# **Harestanes South Windfarm Extension**

## **Environmental Impact Assessment Report Addendum**

### **Appendix A2 – Consultation with ECU (Ironside Farrar)**

### STAGE 1 CHECKING REPORT

**Harestones South  
Windfarm Extension**  
SI Figure 6.1.11: Detailed  
Assessment Areas

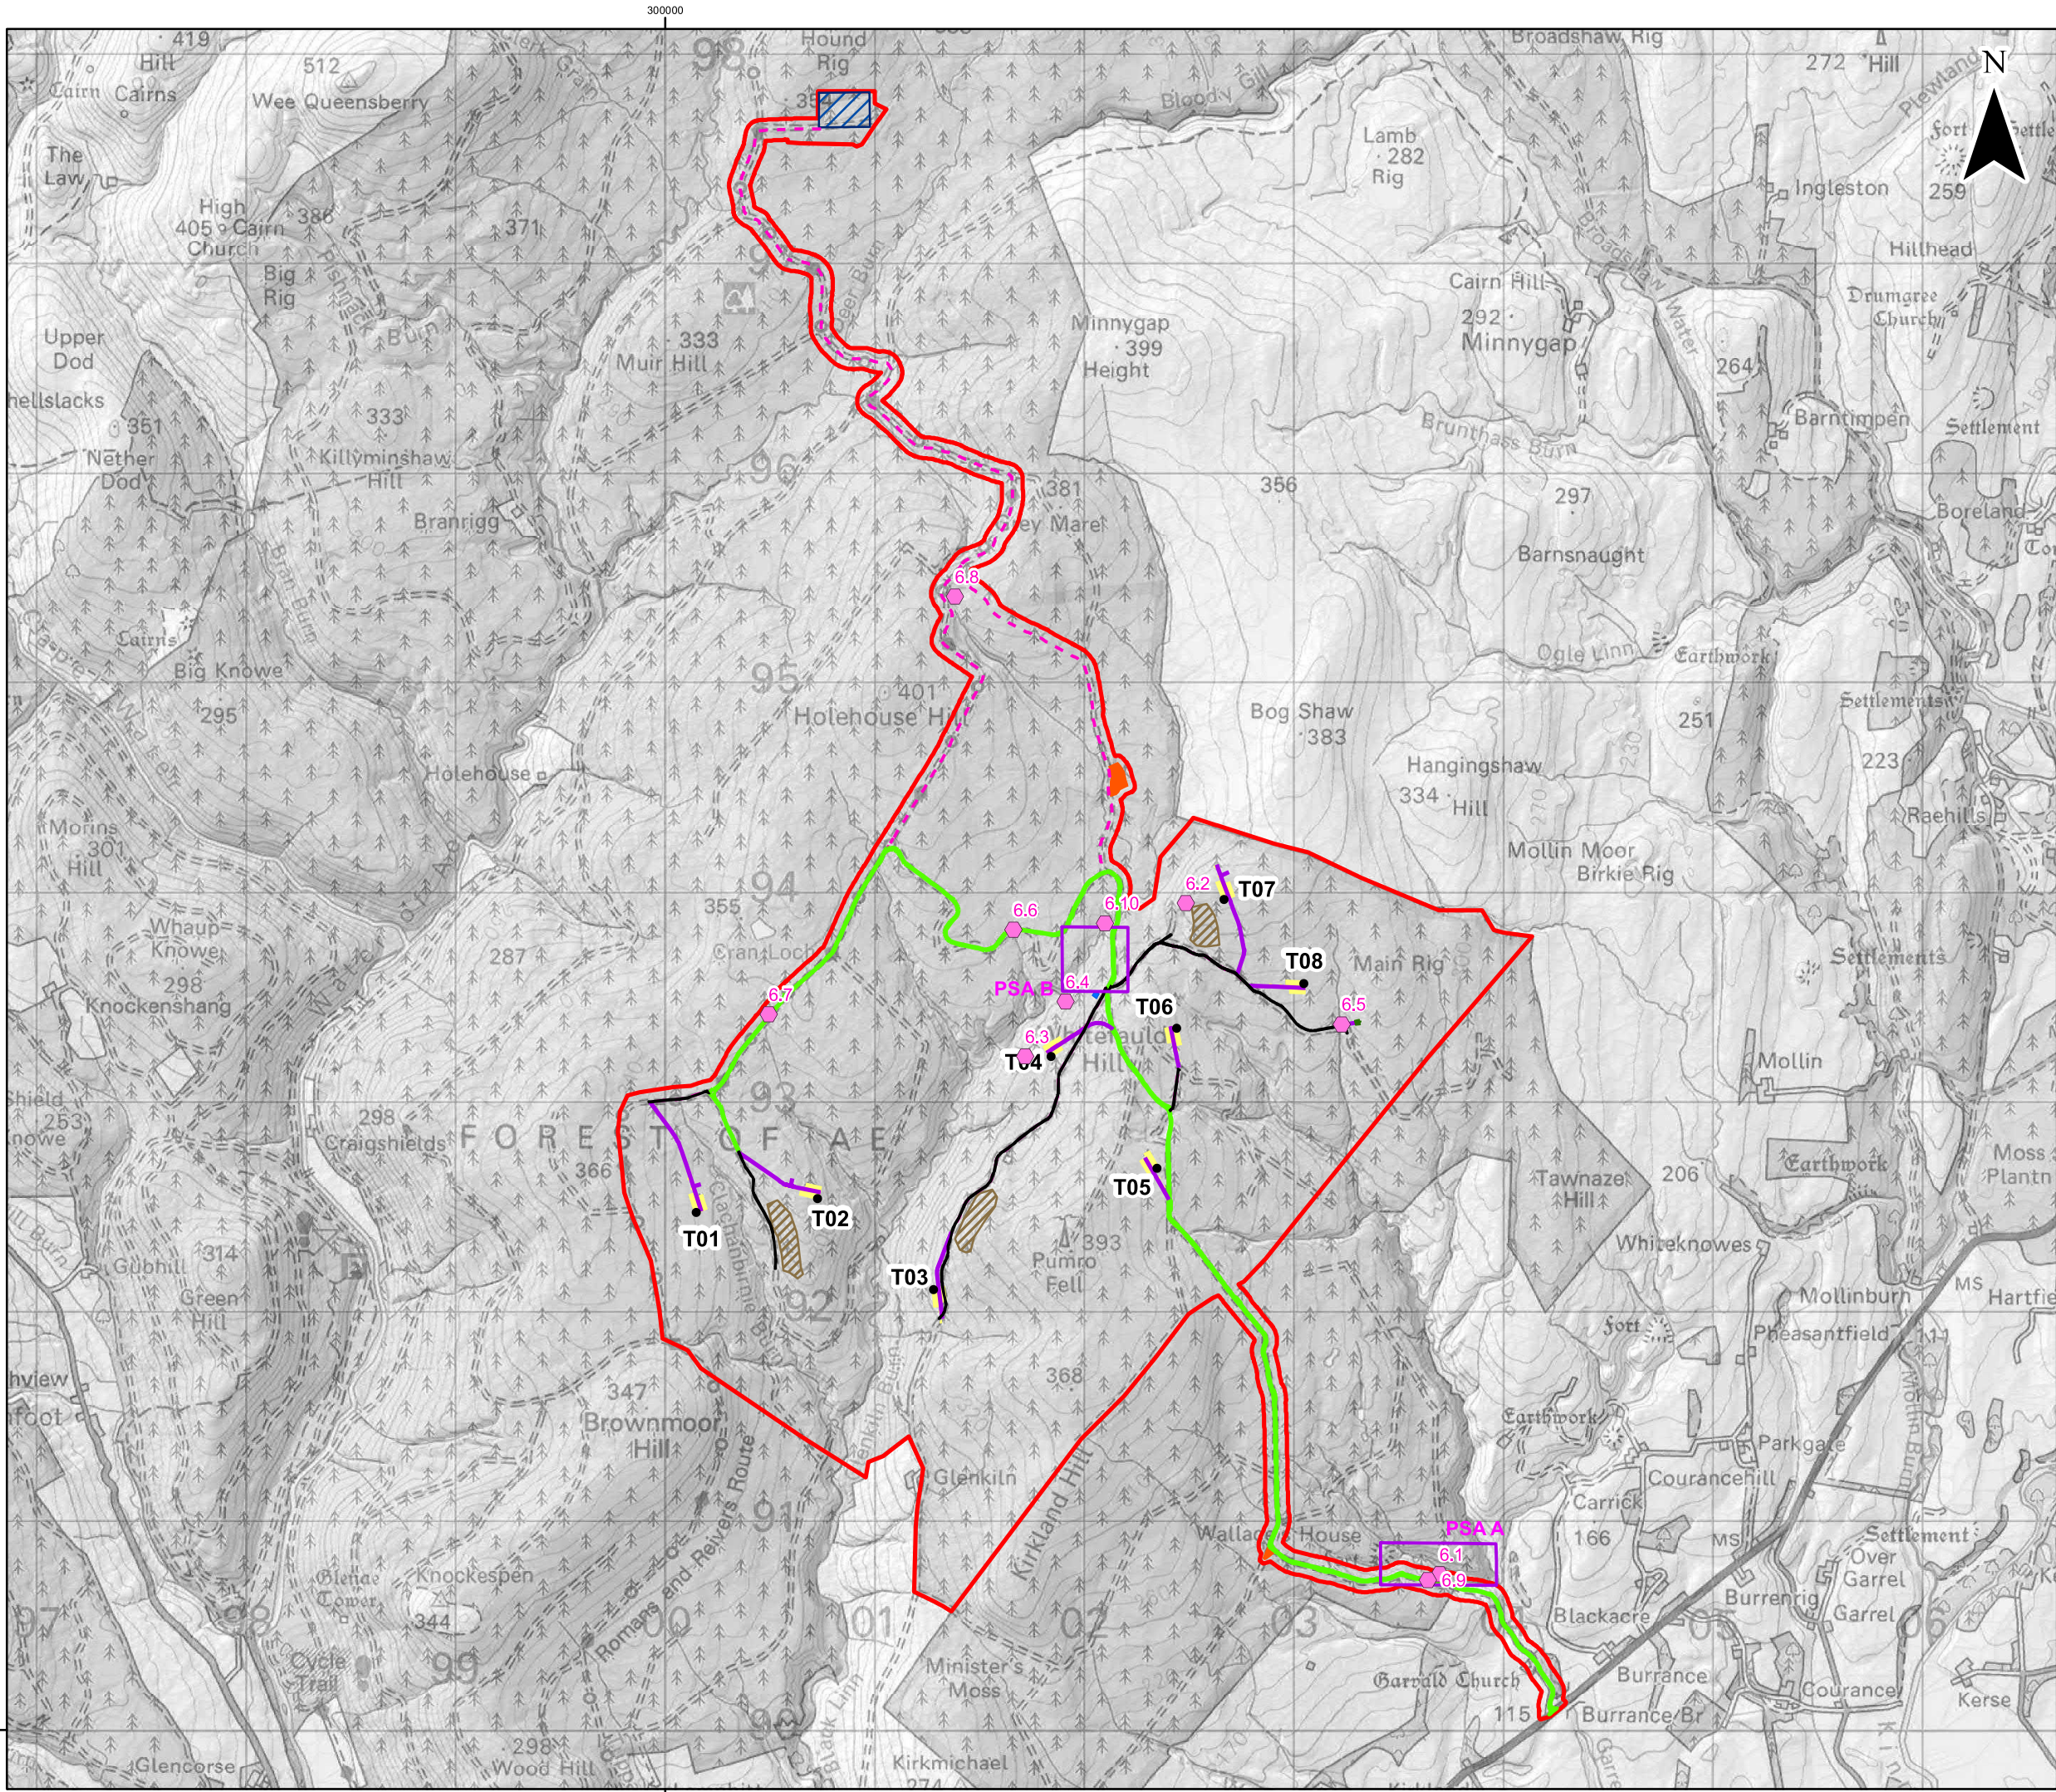
Ironside Farrar commented '*The photograph description may have benefited from a plan showing where the photos and features discussed were located within the site, which would give an understanding how this these features relate to the proposed infrastructure and areas of proposed construction*'. The site reconnaissance photos are now included on the enclosed SI Figure 6.1.11 Detailed Assessment Areas.

**Harestones South Windfarm Extension**  
SI Figure 6.1.12: Geomorphology

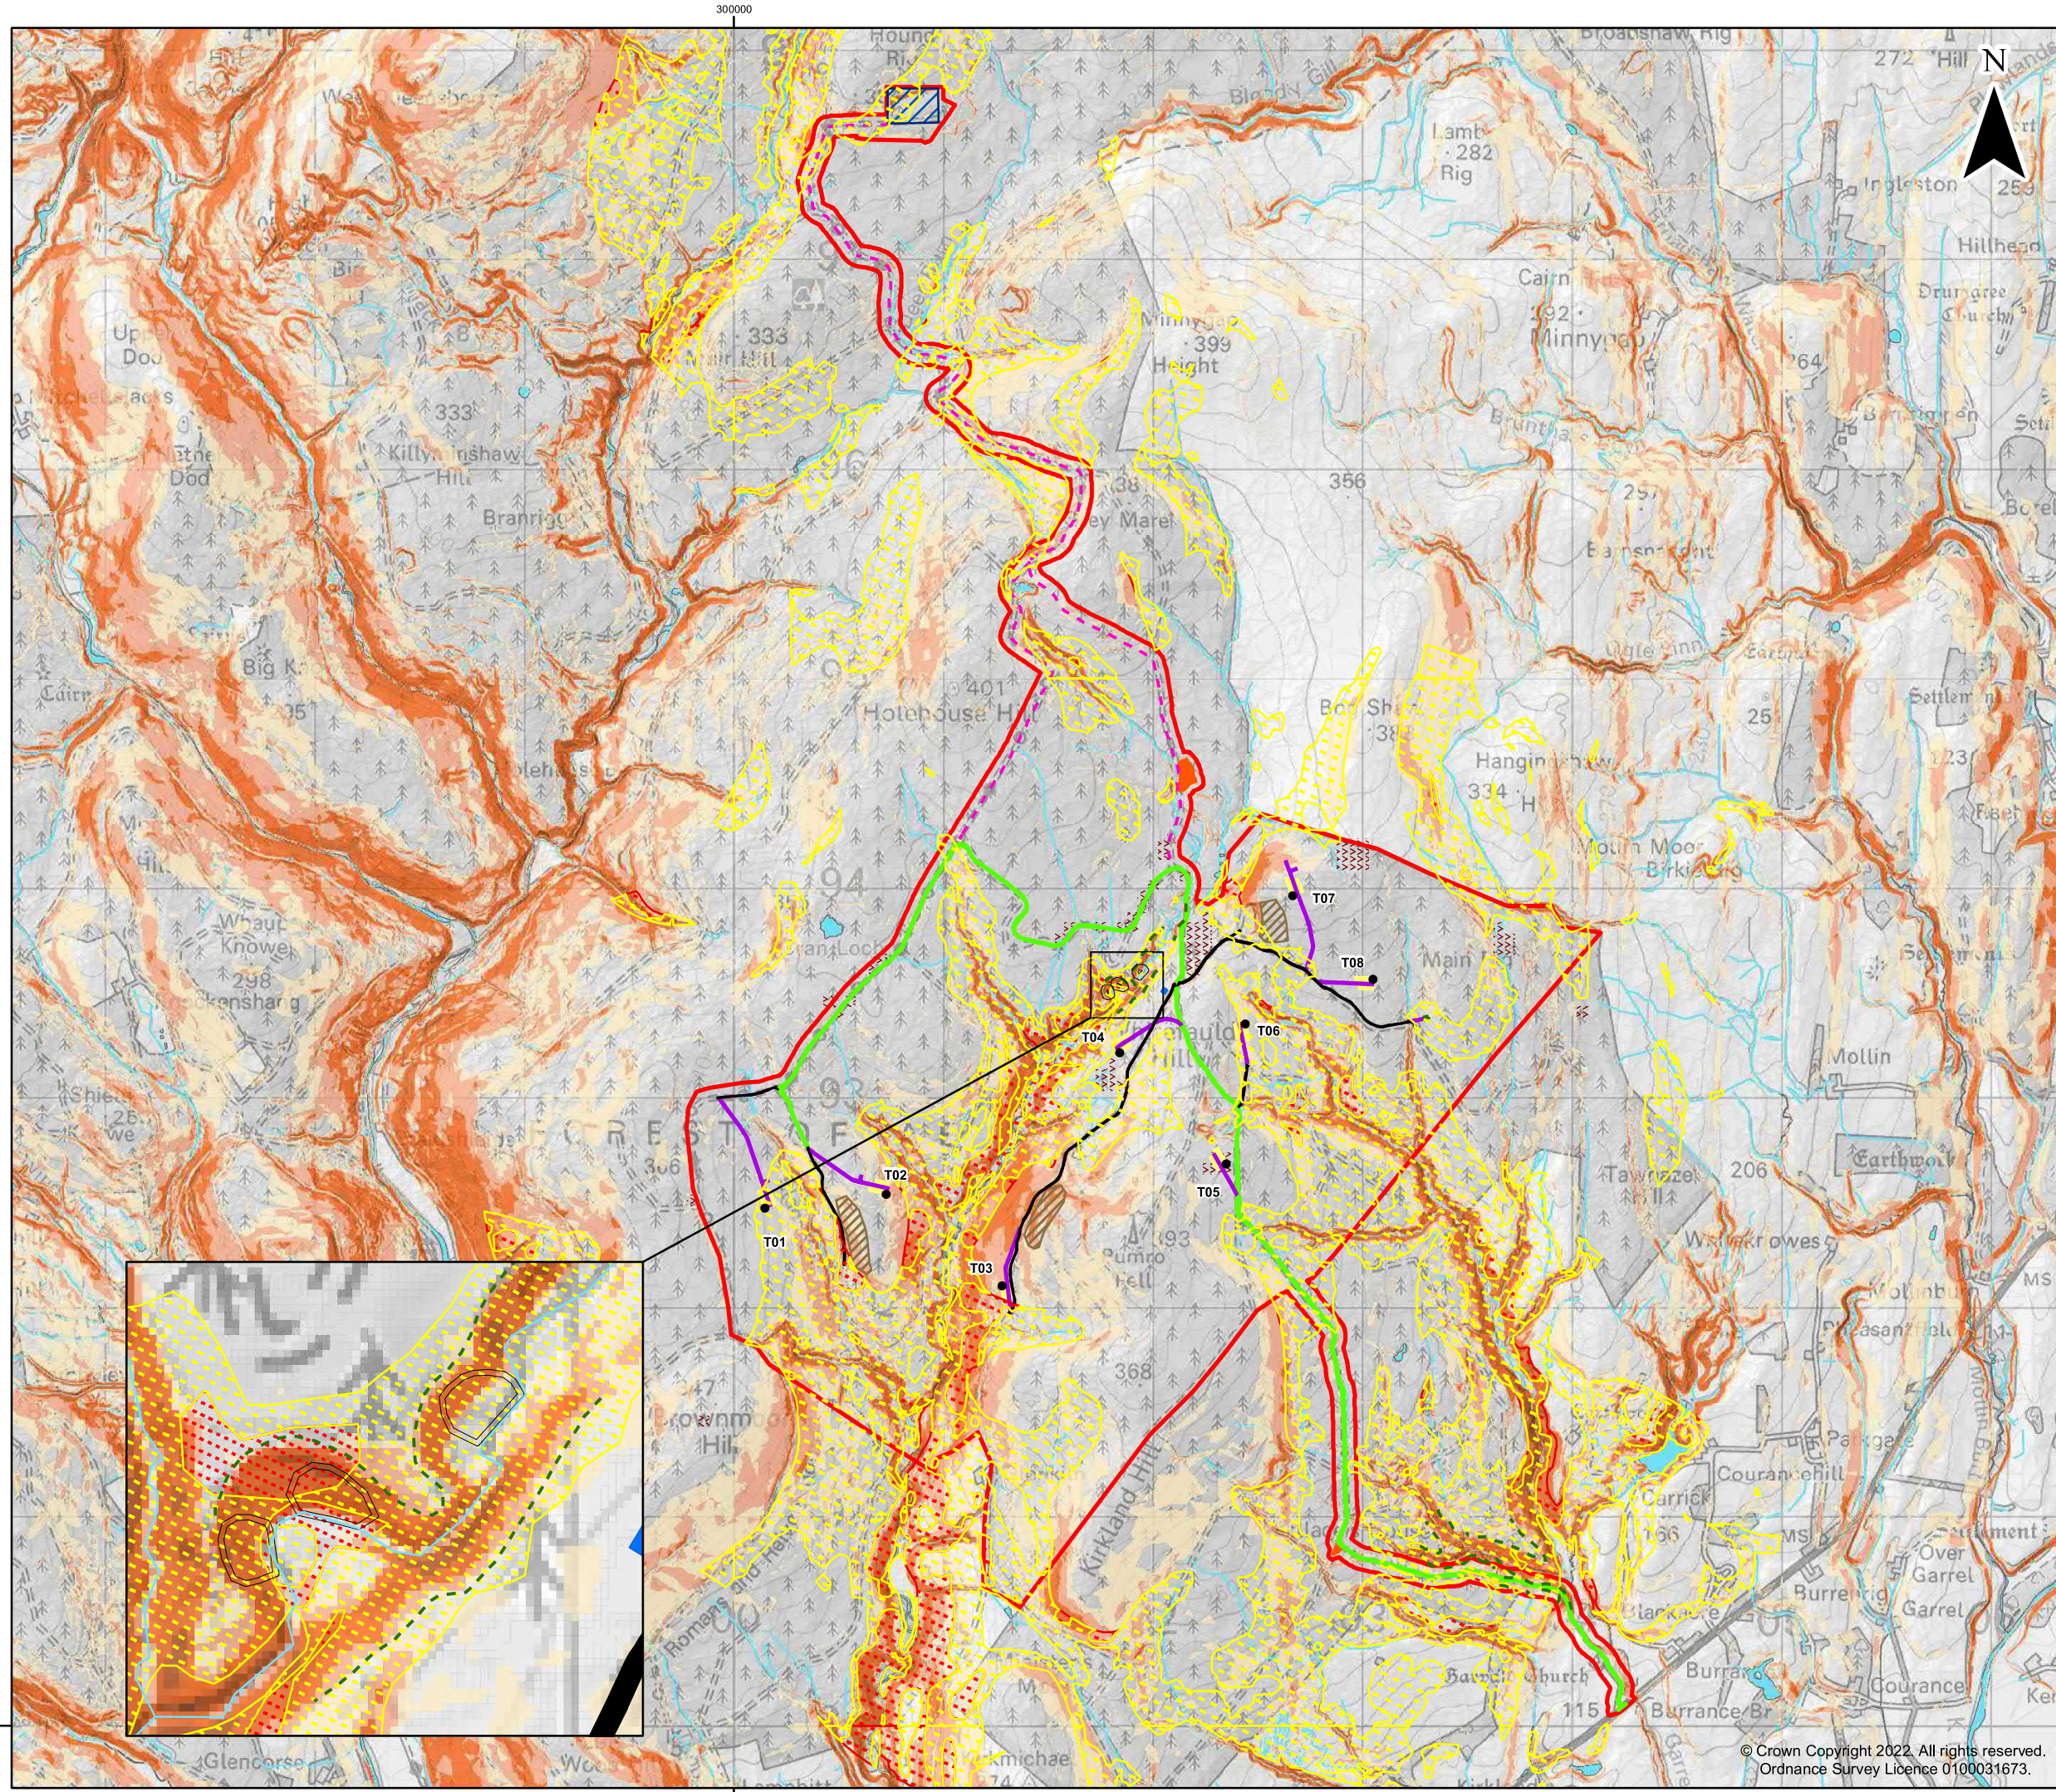
- The stability issues identified by site inspection and desk study should be added to the geomorphological mapping to allow better incorporation into the assessment of risks at the locations identified.

*The stability issues identified by site inspection and desk study should be added to the geomorphological mapping to allow better incorporation into the assessment of risks at the locations identified.*

A number of non-peat related slope failures were observed through aerial imagery review and confirmed on the Site, such as the collapsing watercourse channel banks caused by fluvial erosion adjacent to the incised valley of the Glenkiln Burn tributary. These locations are shown on Illustration 6.1 of the Technical Appendix 6.1 Peat Stability Assessment of the Environmental Impact Assessment (EIA) Report

The results are now included in SI Figure 6.1.12 Geomorphology (appended in this document).
